PSE&G

June 15, 1984

HOPE CREEK GENERATING STATION
DOCKET NO. 50-354
DRAFT SAFETY EVALUATION REPORT
OPEN ITEM STATUS

ATTACHMENT 1

FIGURE 3.8.6

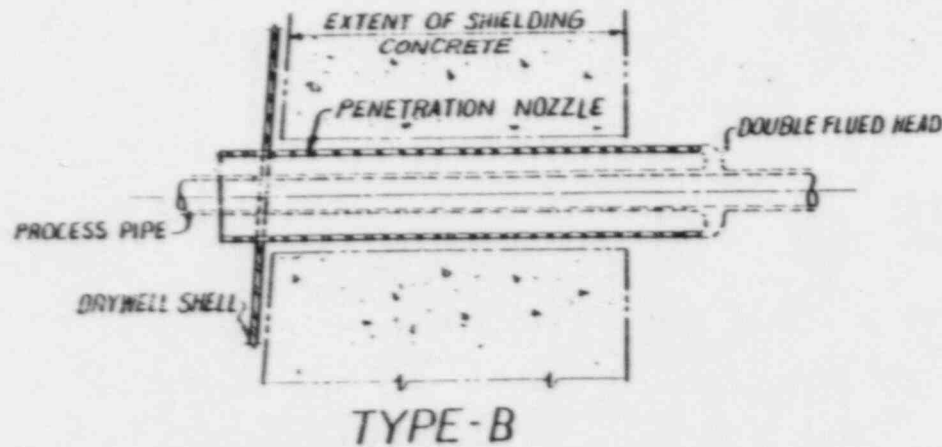
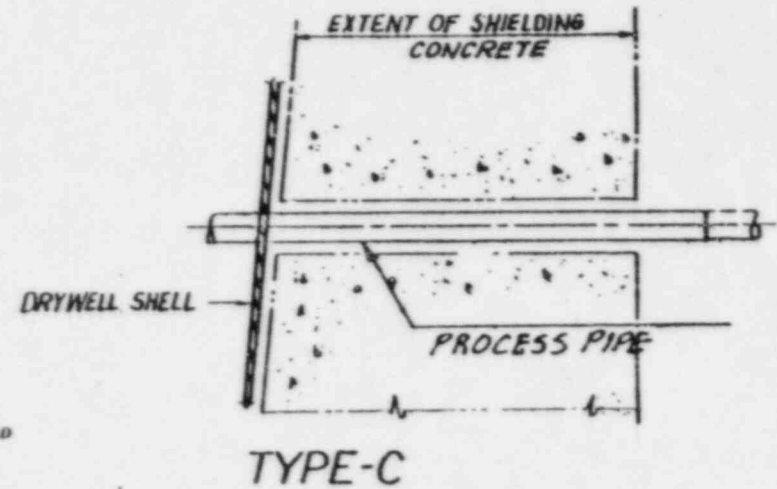
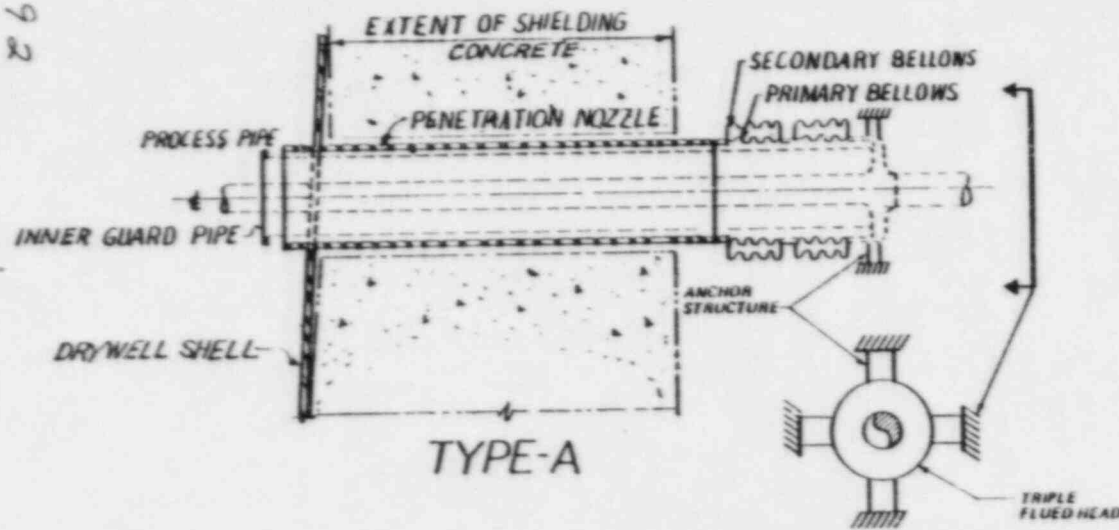
In FSAR Figure 3.8.6, a Type A triple flued head containment penetration with bellows is shown for those cases where thermal expansion is to be accommodated. Provide a list of those systems and the penetration identification numbers where these triple flued head containment penetrations have been used. Describe the design considerations applicable to those penetrations and specifically address how fatigue, torsion, and stiffness modelling in piping analyses were considered.

The Type A triple flued head containment penetrations are anchored to the building steel as shown in revised Figure 3.8-6. In the connecting piping analyses, the flued head is considered a rigid anchor. Piping reaction loads (forces, bending moments and torsion) are evaluated as stated above. Fatigue is considered per item (i) above and includes evaluation of the flued head and the butt weld between the flued head and the process pipe.

FIGURE 6.2-28
SHEET 2 OF 48

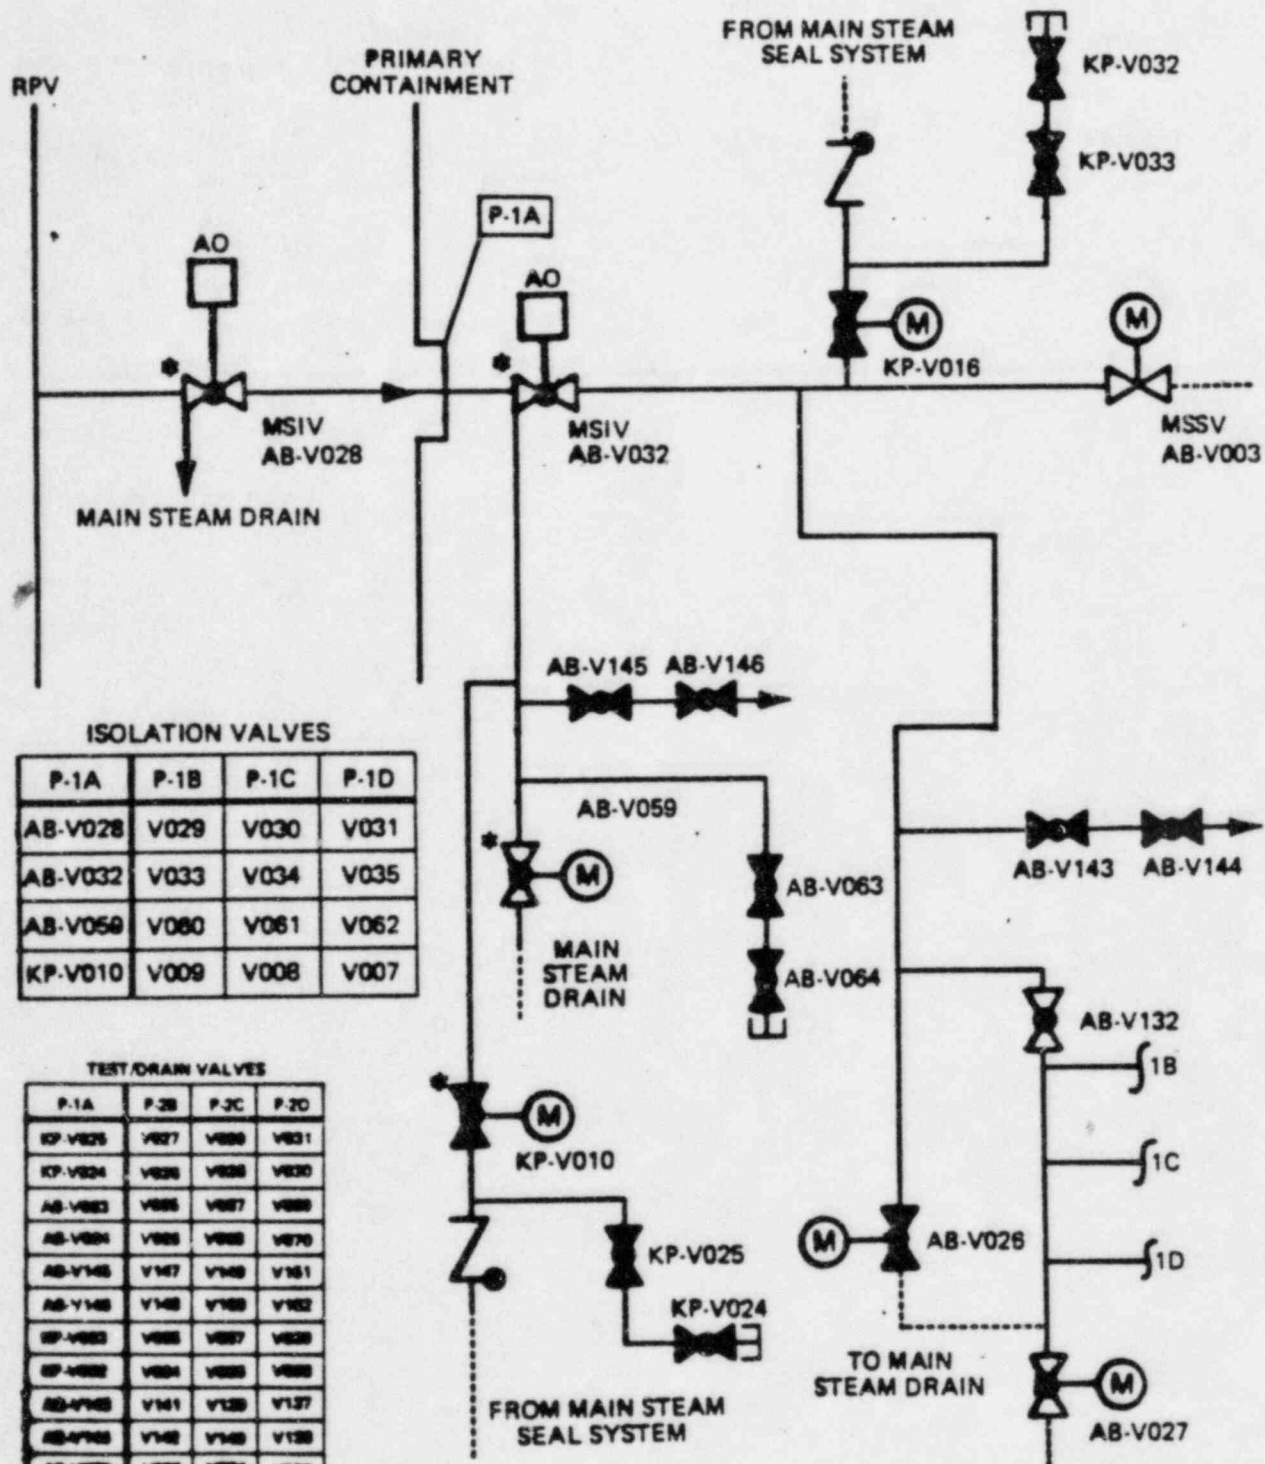
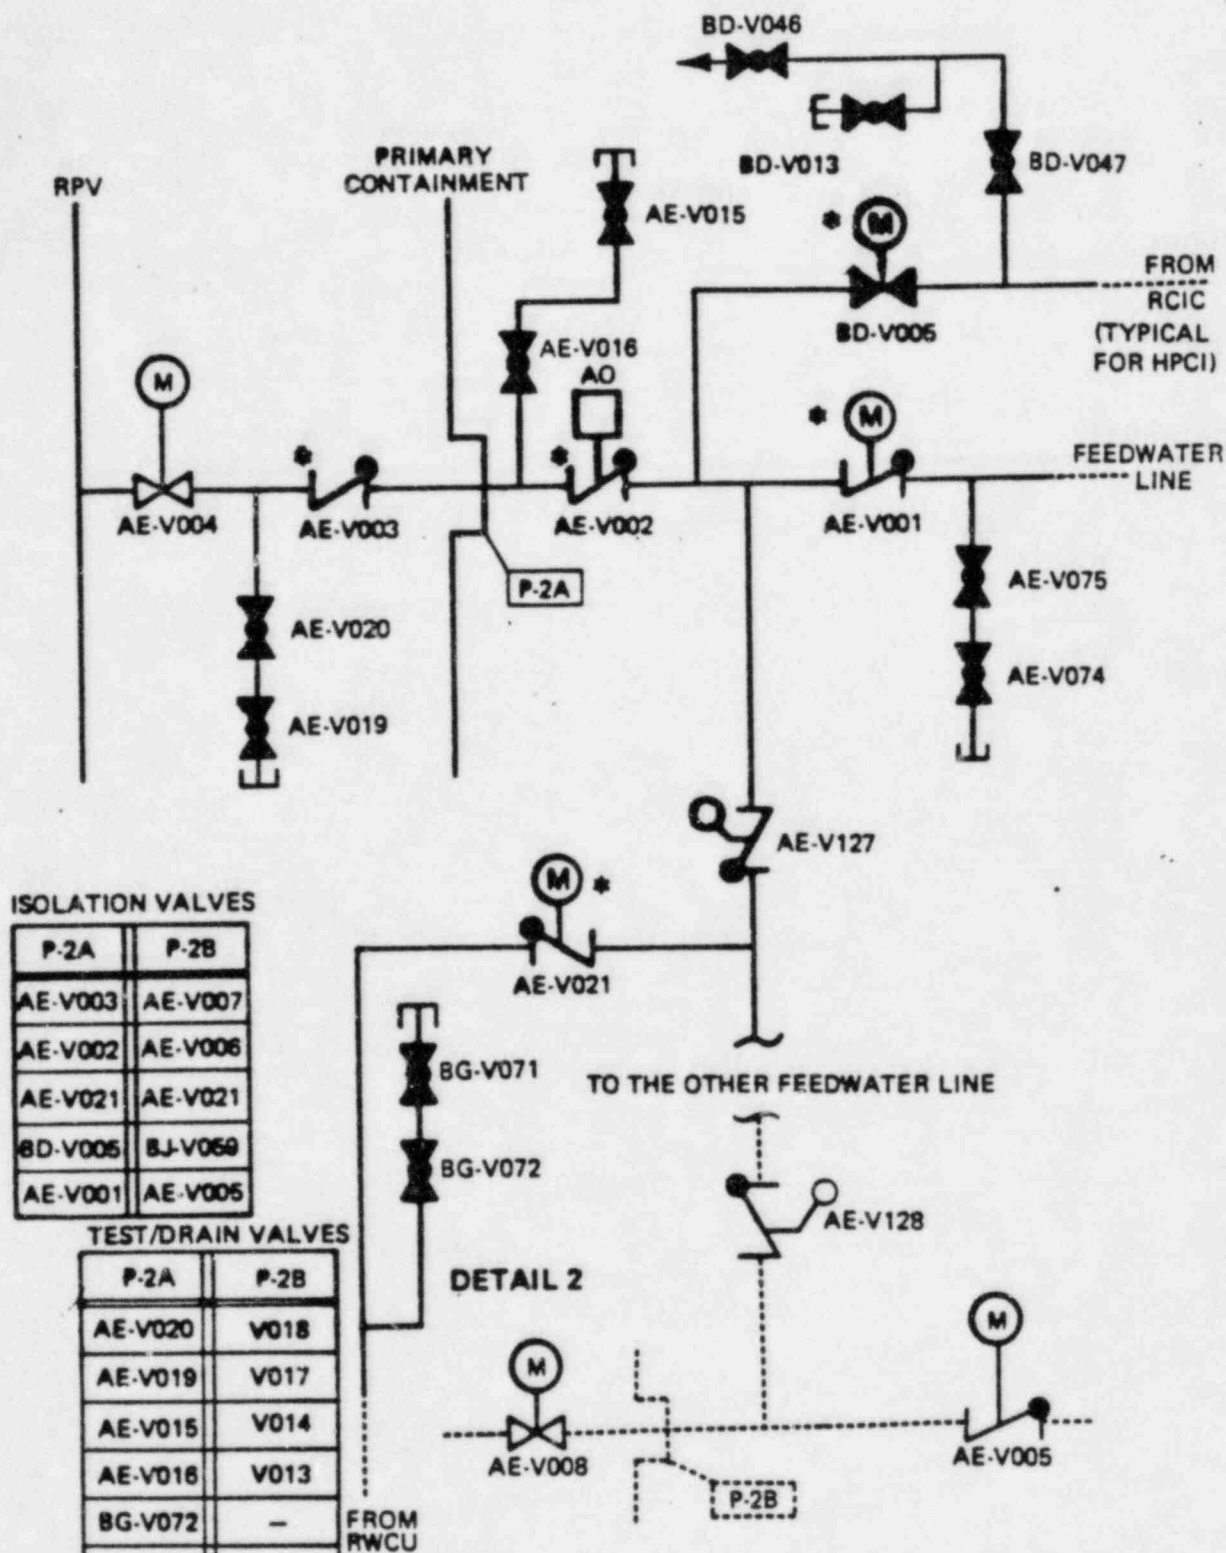
[However, the applicant has not provided the staff with the information requested to conduct the containment isolation review. We will require the applicant to provide for the containment isolation figures contained in the FSAR proper valve identification and the location of the test, vent, and drain lines on these figures. We will also require large enough P&ID drawings in order to conduct our review.] We will report on this matter in a supplement to this SER.

The penetration details in Figure 6.2-28 have been revised to show proper valve identification and the available test provisions.
